Beaver Valley Power Station, Unit No. 2
Docket No. 50-412, License No. NPF-73

Response to Request for Additional Information Related to Beaver Valley Power Station
Unit No. 2 Spent Fuel Pool Rerack License Amendment Request (TAC No. ME1079)

Response to March 19, 2010 NRC Request for Additional Information
Related to Beaver Valley Power Station Unit No. 2
Spent Fuel Pool Rerack License Amendment Request
Page 1 of 12

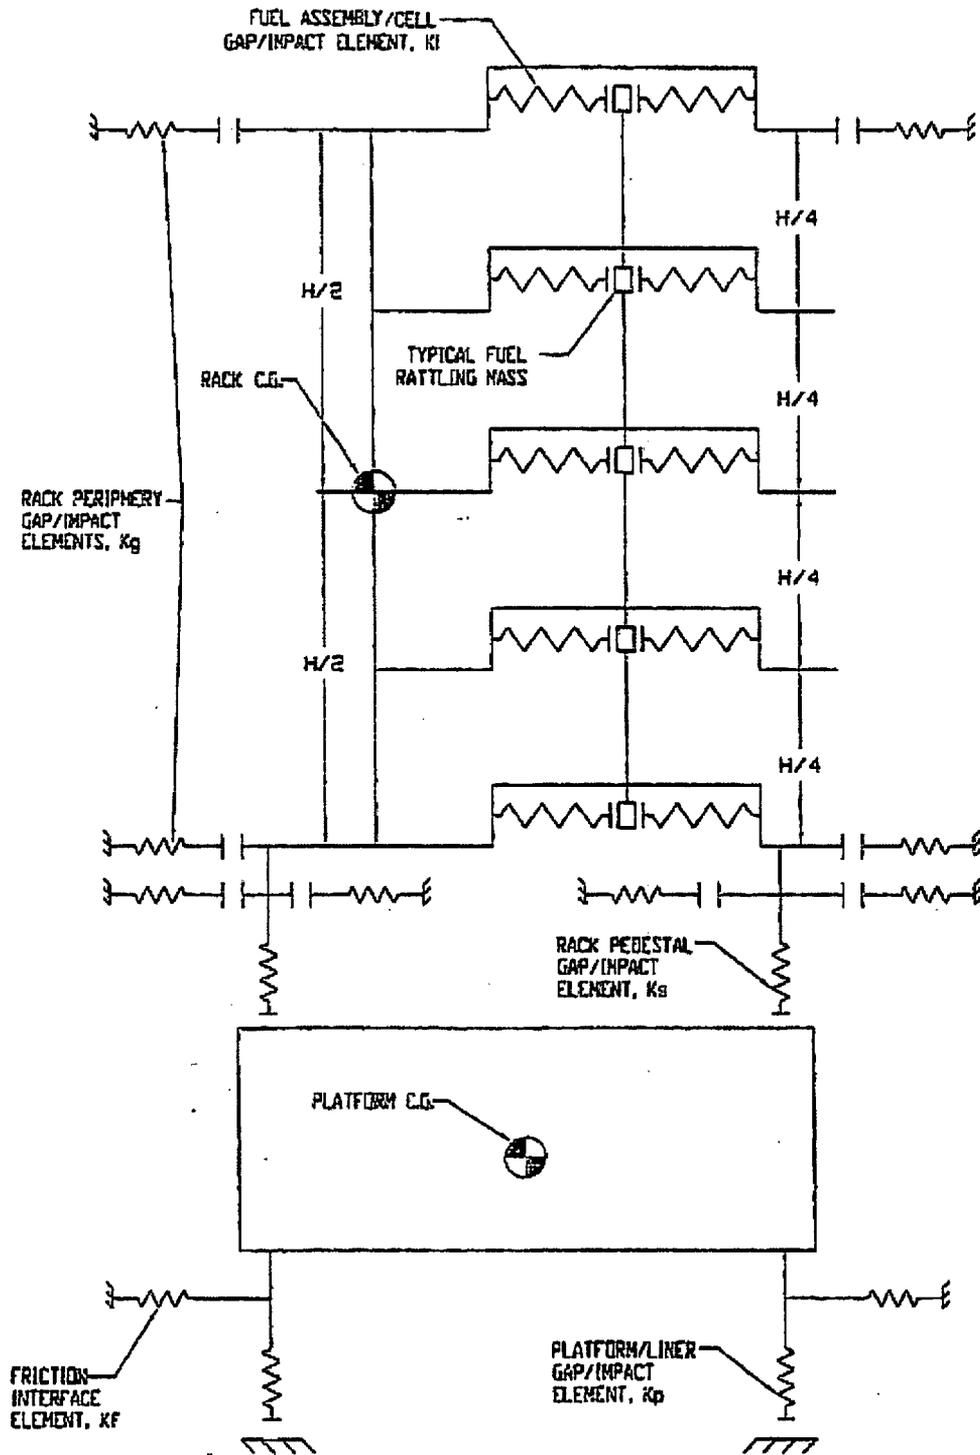
13. Section 5.7 of Enclosure C in Reference 1, "Cask Pit Rack Platform Analysis," stated that a single rack analysis is performed to evaluate the seismic loads induced on the cask pit rack platform. Due to the dynamic characteristics of the cask pit platform, there may be possible amplification of seismic input motion. Provide justification relative to the decoupling of the rack and the cask pit platform in the seismic analysis.

To assess the seismic amplification due to the dynamic characteristics of the cask pit platform, the seismic analysis documented in Reference 3 has been re-performed using a coupled model, which includes both the rack and the cask pit platform. The figure below shows a schematic of the coupled model, which is implemented using the computer program DYNARACK.

The cask pit platform is modeled as a six degree of freedom rectangular body of appropriate size and mass, which is capable of twisting, rocking, and sliding relative to the cask pit floor. The spent fuel rack sits atop the platform in a freestanding manner.

A combination of non-linear gap elements and friction elements are used to define the contact interfaces between the rack support pedestals and the platform, and the platform and the cask pit floor.

The results obtained from the decoupled rack model and the coupled rack/platform model are summarized in the table below.

Based on the above table, the seismic response of the cask pit rack is slightly amplified when the platform is included in the model. The displacements shown above are insignificant, and will neither cause the rack to slide off the platform nor to tip over. Therefore, the stress analysis of the cask pit rack platform has been re-performed (Reference 3) using the maximum pedestal forces from the coupled rack/platform model. The calculated stresses in the platform continue to meet the Level D stress limits per American Society of Mechanical Engineers (ASME) Code, Section III, Subsection NF (Reference 4). The minimum calculated safety factor is 1.084, where

Figure RAI- 20-1 LS-DYNA Model of 12 x 12 Sizewell Rack

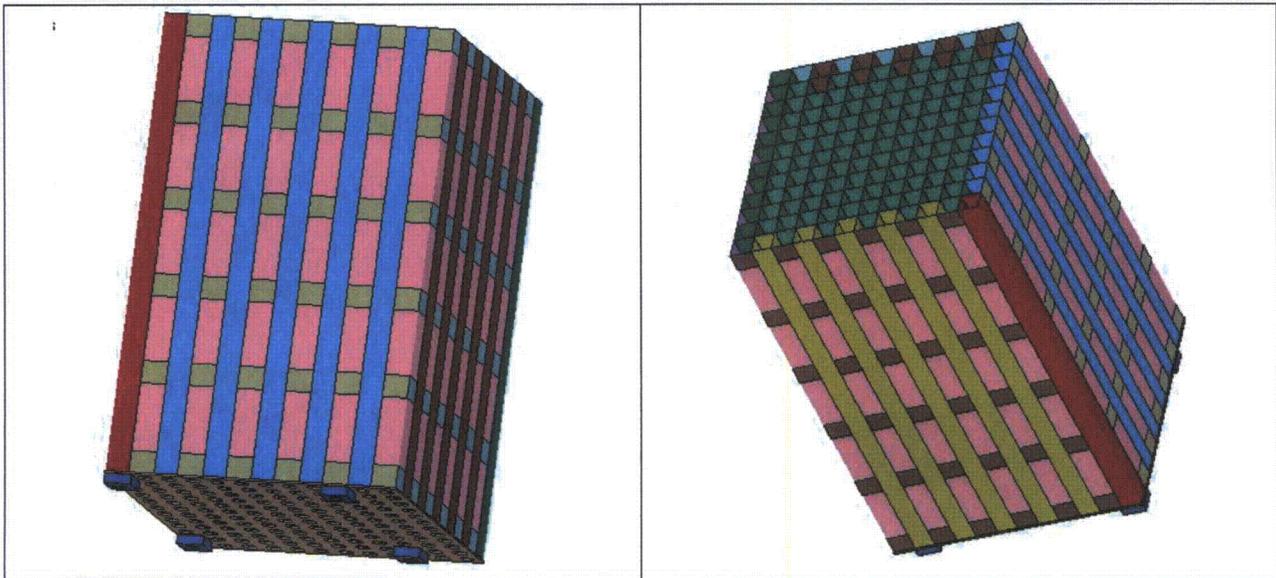
- 20. As discussed in Section 5.4.2.1 of Reference 1, a simplified 3-D lumped mass dynamic model of the single rack structure is used in the whole pool multi-rack analysis. Response 6 in Reference 2 indicated that the use of a single-beam and two-node to model a BVPS-2 rack module is justified because the lowest natural frequency of the rack cellular structure is above 33 Hertz. Please provide more information relative to benchmarking of this model against a detailed finite element model to demonstrate the adequacy of the simplified mass model to predict the anticipated time history seismic responses.**

In 2008, Holtec developed a detailed finite element model of a 12 by 12 pressurized water reactor (PWR) spent fuel rack (Reference 6) for Sizewell nuclear plant. This nuclear power plant is located in England and operated by British Energy. The model, which is shown below in the Figure RAI-20-1, was built using LS-DYNA.

As shown in the figure above, all load bearing components of the spent fuel rack, including the support pedestals, the base plate, the cell walls, and the weld connections, were modeled explicitly using a combination of thick shell, shell, and solid elements. In addition to the rack structural components, the stored fuel assemblies were individually modeled in LS-DYNA as separate bodies and positioned within every storage cell location. Appropriate contact interfaces were defined between the cell walls, the base plate, and the fuel assemblies to allow each fuel assembly to rattle freely inside its storage cell under the applied loading. The entire model included nearly 200,000 elements.

As expected, the DYNARACK model predicts larger rack displacements than LS-DYNA mainly because of the conservative manner in which rattling fuel assemblies are modeled in DYNARACK. The DYNARACK model assumes that all fuel assemblies rattle in-phase by virtue of the fact that the total mass of the stored fuel assemblies is lumped into a single fuel column. By contrast, the fuel assemblies are individually modeled in LS-DYNA, and therefore they are capable of rattling out-of-phase (as would actually occur in a seismic event). Out-of-phase rattling reduces the net impact between the stored fuel and the spent fuel rack, which in turn leads to smaller rack displacements. Thus, the simplified mass model utilized in DYNARACK provides a conservative prediction of the maximum rack displacements and fuel-to-cell impact load.
